**Re: Farolito Senior Community/ 10501 Central Ave NE  
Request for Certificate of Occupancy  
Transportation Development Final Inspection**  
Architect's Stamp dated 09-05-2023 (L21D074)  
Certification dated 11-18-2025  
TRANS-2025-00334

Re: Traffic Certification for Certification of Occupancy  
Development: Farolito Senior Community  
10501 Central Ave. NE  
Albuquerque, NM 87123

DRAWING NAME  
**TRAFFIC CIRCULATION PLAN**

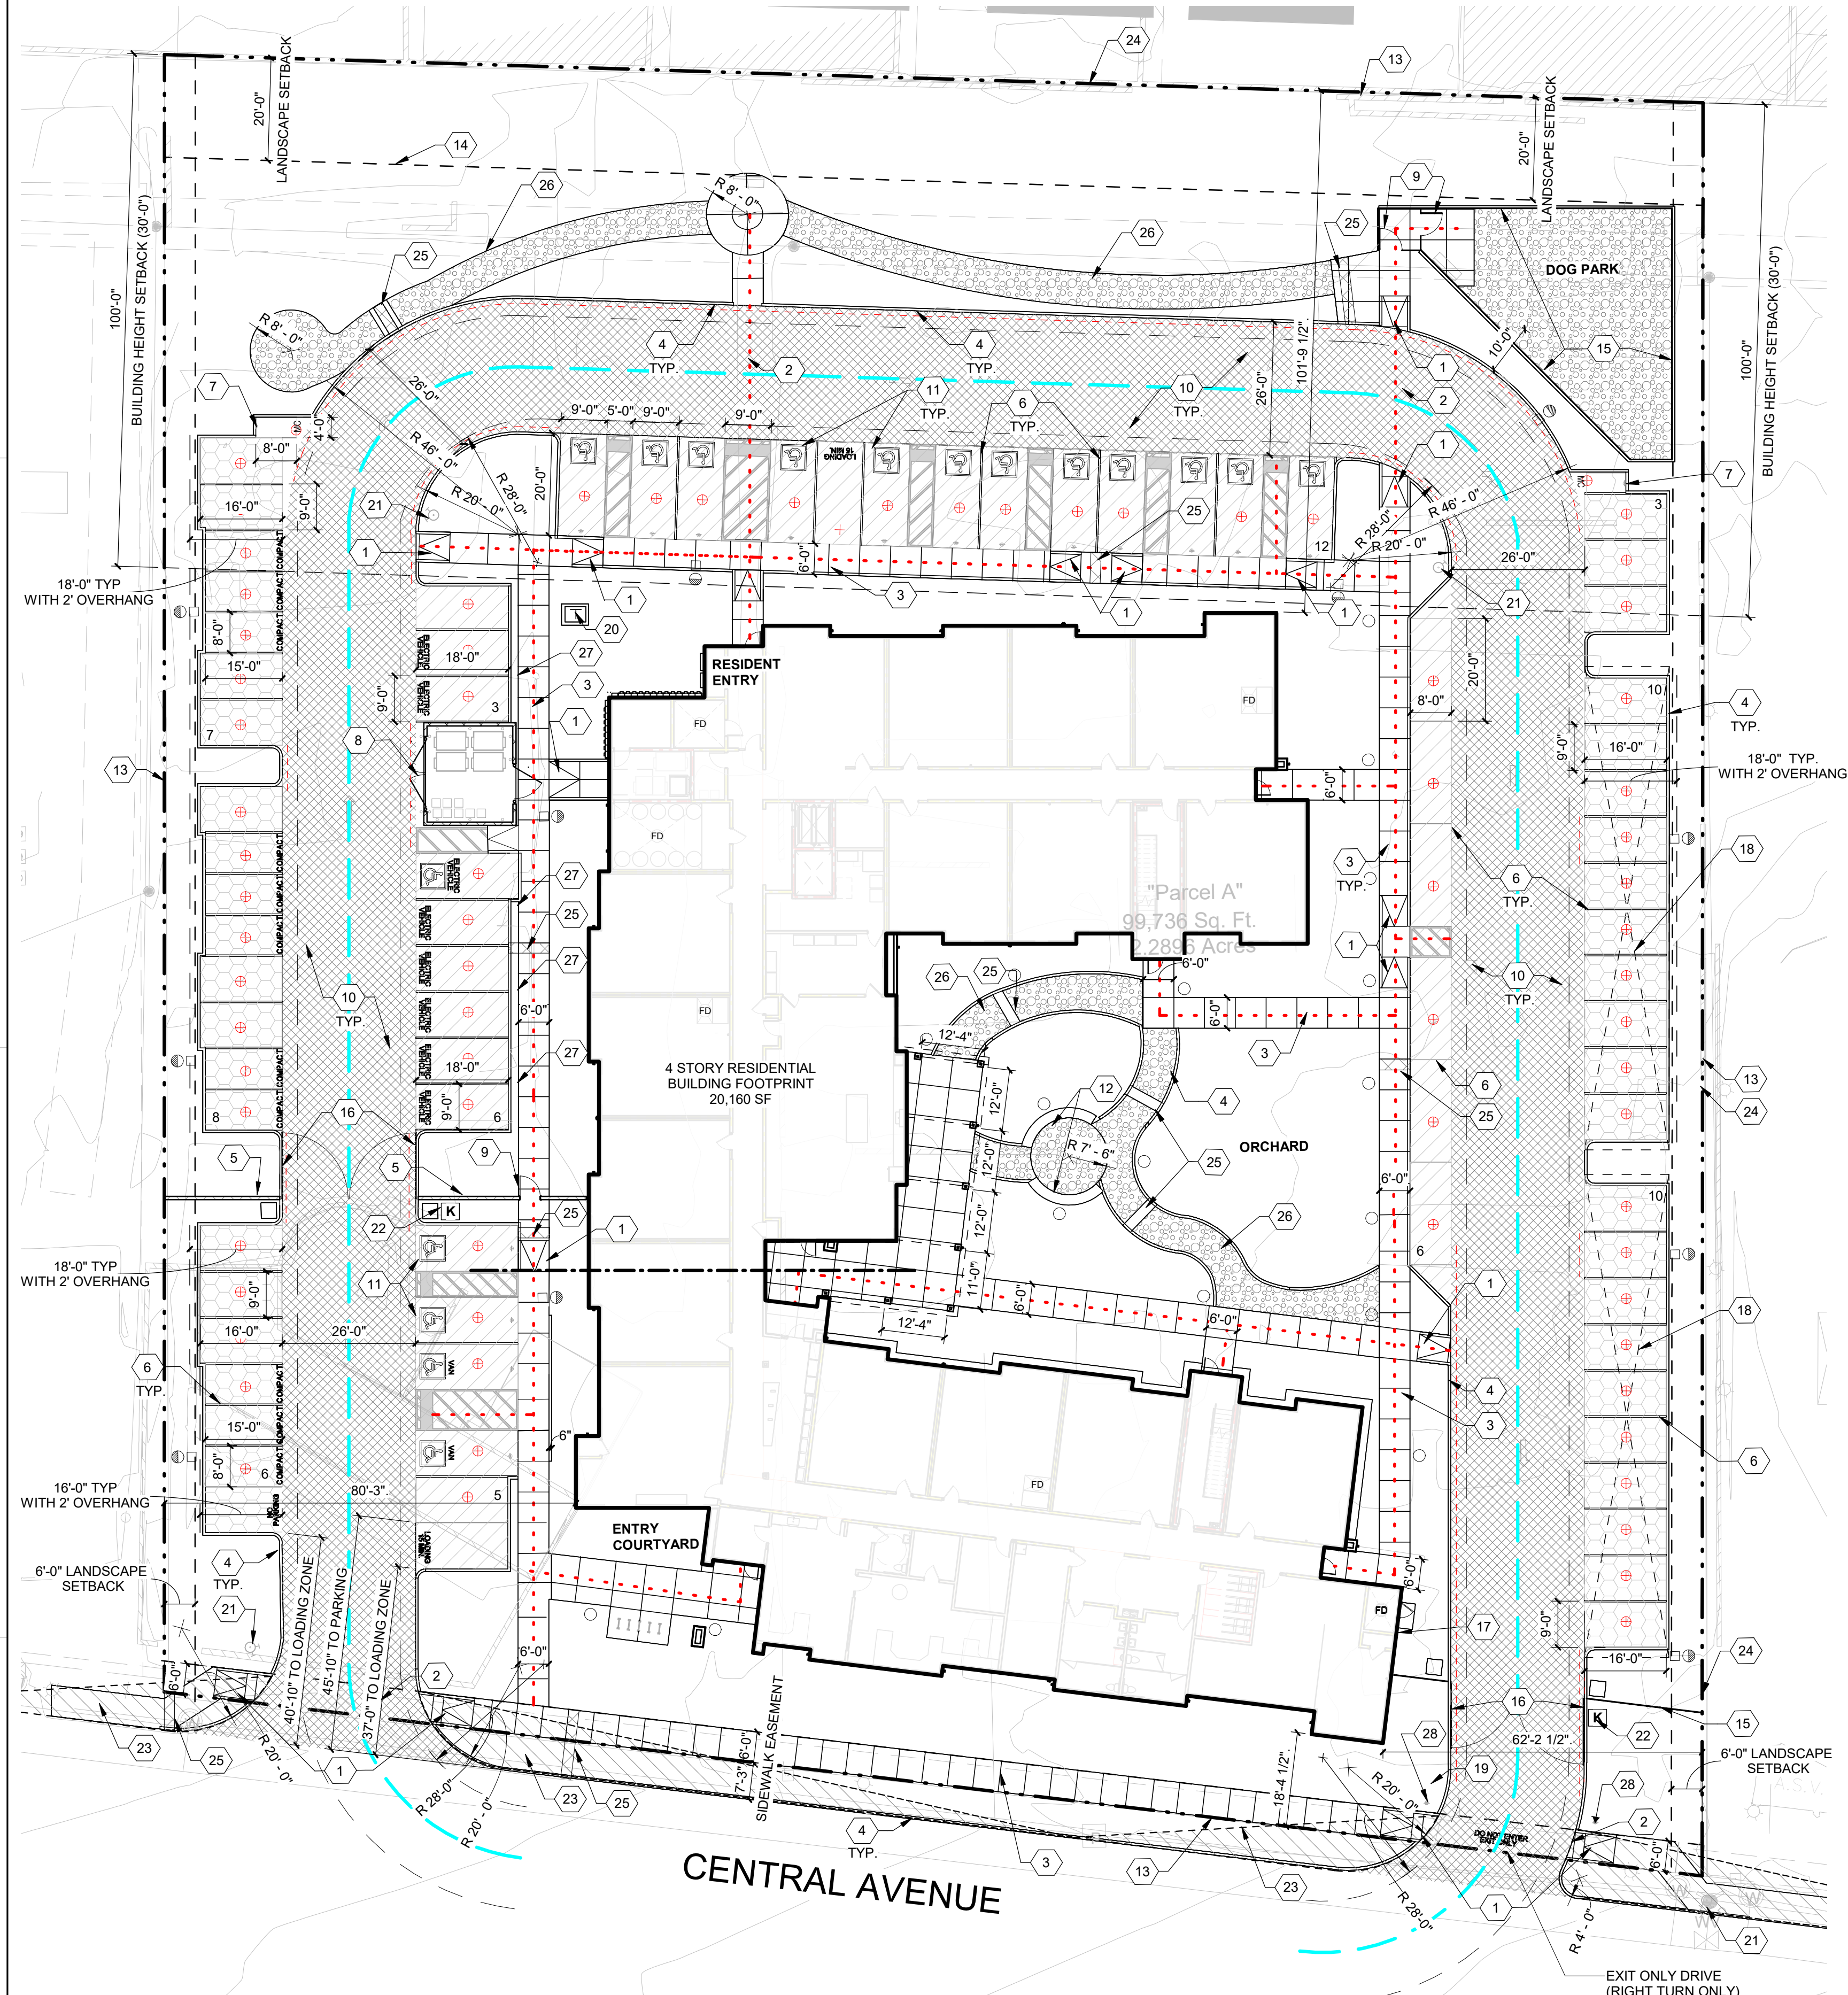
The following items as noted on the attached site plan were identified as incomplete and as such a request for General Contractor / Traffic Inspector field confirmation of completeness and if necessary a request for a deferred approval for 30 days beyond issuance of C of O for the following items:

There are a few minor pavement striping and signage items that would be considered outstanding at this time: three striped parallel spaces adjacent to the courtyard, and three bollard-mounted "Van" accessible parking signs were missing the "Van" designator in addition to their accessible signs, 5 bike racks outside the main entrance were staged but not installed.

Based upon the information provided in your submittal received 11-18-2025, Transportation Development has no objection to the issuance of a Permanent Certificate of Occupancy. This letter serves as a "green tag" from Transportation Development for a Permanent Certificate of Occupancy to be issued by the Building and Safety Division.
